PORTLAND HARBOR PROPOSAL PLAN COMMENTS

SILTRONIC CORPORATION

PREPARED FOR
SILTRONIC CORPORATION
SEPTEMBER 6, 2016
PROJECT NO. 8128.02.03

Path: X:\1218.02 Siltronic Corp\1302\Projects\Fig8_Technology Assignment Decision Tree.mxd
Print Date: 8/29/2016
Reviewed By: P. Wiescher
Produced By: apadilla

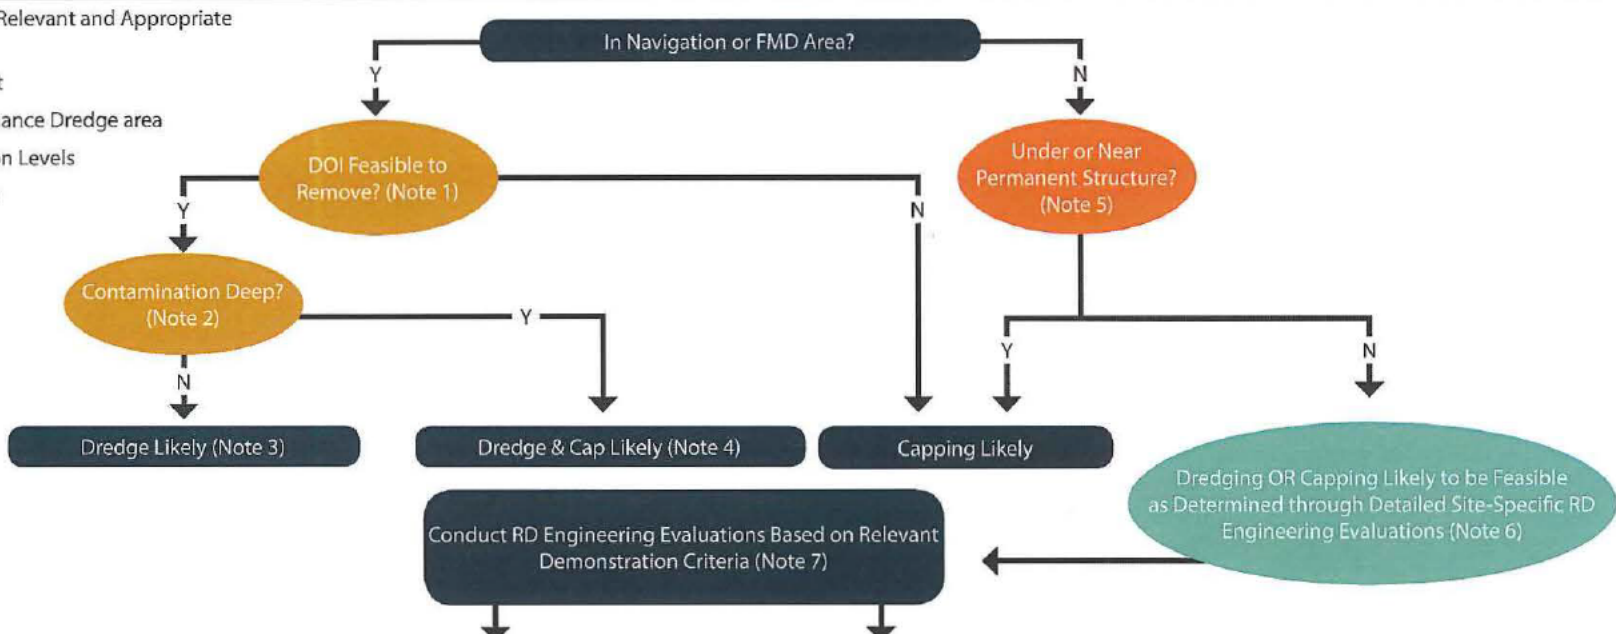
Siltronic recognizes that the decision trees that were prepared for the FS and carried to the PP as Figures 10a through 10d provide for a level of consistency in how EPA made technology assumptions for the purposes of cost estimating. However, these decision trees do not allow designers to confirm that the technology is feasible on a site-specific basis, from both an engineering and regulatory standpoint. To address this, Siltronic supports the development of a simplified decision tree for the predesign technology assignments that provides a clear and effective roadmap for design demonstrations based on site-specific conditions, as shown in Figure 8.²¹

Siltronic recommends that, rather than assigning remedial technologies in the ROD, EPA provide performance goals for each of the remedial designs—for example: “extent of contamination shall be accurately mapped to facilitate efficient removal”; “sediment removal prisms shall be designed to accurately reflect the horizontal and vertical extent of contamination and incorporate the physical conditions of the site”; “implementation methods shall be used that do not cause routine exceedance of water quality standards”; “sediment removal design shall implement dredging best management practices (BMPs) to limit the generation of residuals,” as described in U.S. Army Corps of Engineers guidance.²² Such performance goals would help ensure that sufficient flexibility is retained and appropriate and effective remedy techniques can be implemented.
